# UNITED STATES PATENT AND TRADEMARK OFFICE

APPLICATION NO.	FILING DATE	FIRST NAMED INVENTOR	ATTORNEY DOCKET NO.	CONFIRMATION NO.
10/711,640	09/29/2004	Basanth Jagannathan	FIS920040085	5639

<b>Office Action Summary</b>	<b>Application No.</b> 10/711,640	<b>Applicant(s)</b> JAGANNATHAN ET AL.	
	<b>Examiner</b> Tram H. Nguyen	<b>Art Unit</b> 2818

### DETAILED ACTION

**FIG. 1H**

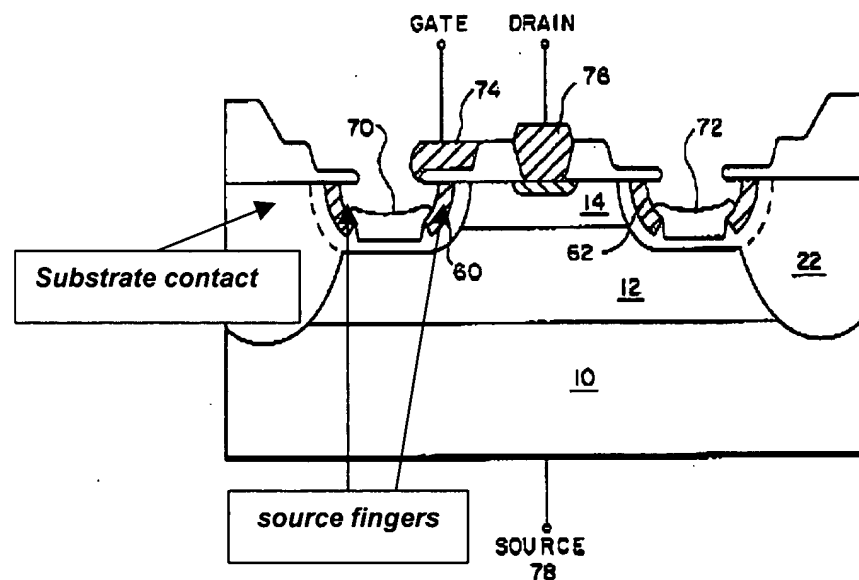
Regarding **claim 18**, Herzum discloses all the limitation of the claimed invention for the same reasons are set-forth above except for not explicitly teach the source comprises a source finger and the substrate contact abuts substantially all of one side of the source finger. However, Rice has a similar structure (fig. 1H) (Note: the current flows through the substrate contact (described in col. 4, lines 36-38)) wherein the source comprises a source finger and the substrate contact (reference numeral 20) abuts all of one side of the source finger (reference numeral 60) (col. 4, line 19).

Regarding **claim 19**, Herzum and Rice disclose all the limitations of the claimed invention for the same reasons are set-forth above; likewise, Rice also teaches two source fingers arranged within substrate, wherein the substrate contact abuts two of the two source fingers (refer the above fig. 1H).

**FIG. 1H**

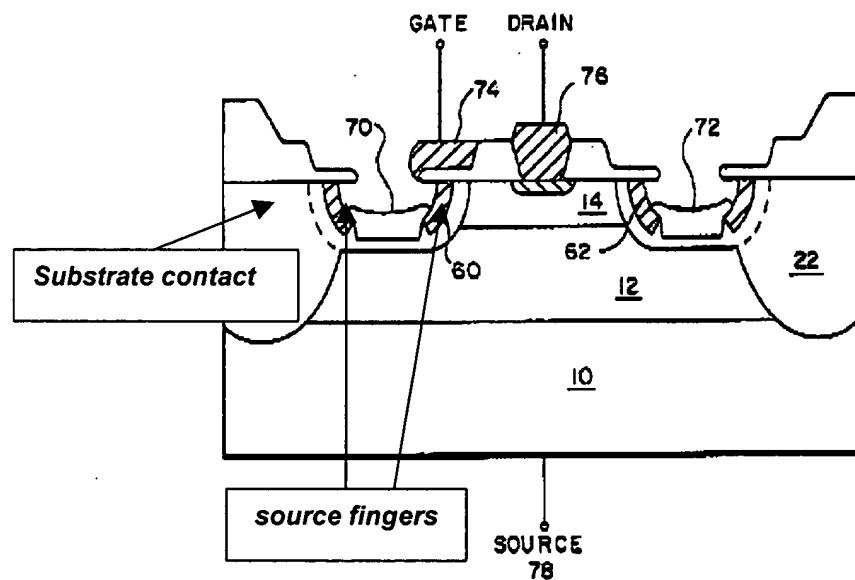
Regarding **claim 37**, Herzum discloses all the limitation of the claimed invention for the same reasons are set-forth above except for not explicitly teach the source comprises a source finger and the substrate contact abuts substantially all of one side of the source finger. However, Rice has a similar structure (fig. 1H) (Note: the current flows through the ring substrate contact (described in col. 4, lines 36-38)) wherein the source comprises a source finger and the ring substrate contact (reference numeral 20)

Regarding **claim 38**, Herzum and Rice disclose all the limitations of the claimed invention for the same reasons are set-forth above; likewise, Rice also teaches two source fingers arranged within substrate, wherein the substrate contact abuts two of the two source fingers (refer the above fig. 1H).
